**PLANNED UNIT DEVELOPMENT
STAFF REPORT**

Amity Missionary Baptist Church

Planned Unit Development Approval to allow off site parking for a proposed church.

SITE PLAN

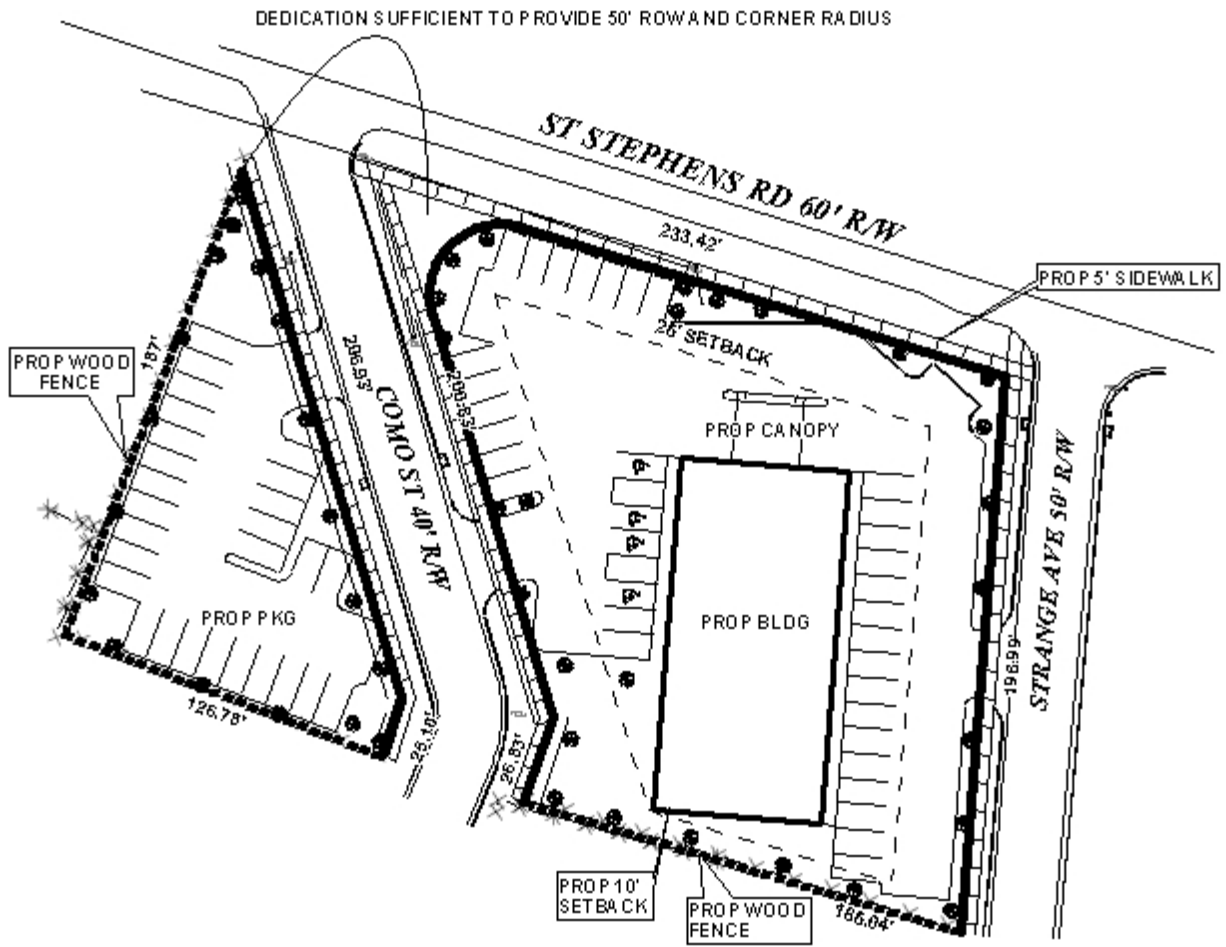
The site fronts onto St. Stephen's Road, a proposed major street, and onto Como and Strange Streets, both minor streets, however the right-of-way for Como is only 40-feet in width, which is below the minimum 50-feet normally required for minor streets. It appears that many streets in the vicinity have 40-foot right-of-ways. Dedication along Como Street is depicted to provide a sidewalk on the West side of the street, which will serve as a stand-alone parking area for the church, as was required by the Subdivision approval. Dedication is also depicted on the East side of Como Street, at the Southeast corner where Como Street meets St. Stephen's Road, as required by the Subdivision approval. The 25-foot minimum building setback line from all dedicated rights-of-way should be depicted on the site plan for both lots.

As St. Stephen’s Road is a proposed major street, with a fairly narrow right-of-way, and as the site abuts two minor streets that primarily serve existing residences, access management is a concern. The applicant is proposing one curb-cut for proposed Lot 1 onto Como Street, and one curb-cut for Lot 2 onto Como Street and one curb-cut onto Strange Avenue. No curb-cuts are proposed onto St. Stephen’s Road. The size, design and location of all curb-cuts must be approved by Traffic Engineering and conform to AASHTO standards.

The site will abut residential zones to the South, thus a vegetative buffer or fence in compliance with Section 64-4.D.1. of the Zoning Ordinance will be required. The site plan should be modified to reflect either a fence or 10-foot wide vegetative buffer.

Regarding tree and landscape compliance, the site plan should be revised to label each lot with its size in square feet, after right-of-way dedication, and tree and landscape calculations should be calculated for each lot individually, including the break-out for frontage trees and frontage landscape areas.

If a dumpster will be provided for the church, it should be depicted on the site plan, or a note should be placed on the plan stating that no dumpster will be utilized.

- 1) Limited to the provided site plan, as revised per this approval;
- 2) Provision of a 6-foot high wooden privacy fence in compliance with Section 64-4.D.1. of the Zoning Ordinance, except within the required 25-foot minimum building setback (where the fence shall be 3-feet high);
- 3) Compliance with parking area screening requirements of Section 64-6.A.3.i. of the Zoning Ordinance;
- 4) Compliance with the site and parking area lighting requirements of Sections 64-4.A.2. and 64-6.A.3.c. of the Zoning Ordinance;
- 5) Compliance with the tree and landscaping requirements of the Zoning Ordinance, and revision of the site plan to break-out the tree and landscape area information for each lot separately;

- 6) Revision of the site plan to label each lot with its size in square feet, reflecting dedication required by the Subdivision approval;
- 7) Depiction and labeling of the 25-foot minimum building setback line from all streets, including the setback line along Como Street to reflect dedication;
- 8) Revision of the site plan to depict a dumpster, if one will be used, or placement of a note stating that no dumpster will be utilized;
- 9) Placement of a note on the site plan stating that development of the site must be undertaken in compliance with all local, state and Federal regulations regarding endangered, threatened or otherwise protected species;
- 10) Provision of a revised PUD site plan to the Planning Section of Urban Development prior to the signing of the Subdivision plat; and
- 11) Full compliance with all municipal codes and ordinances.
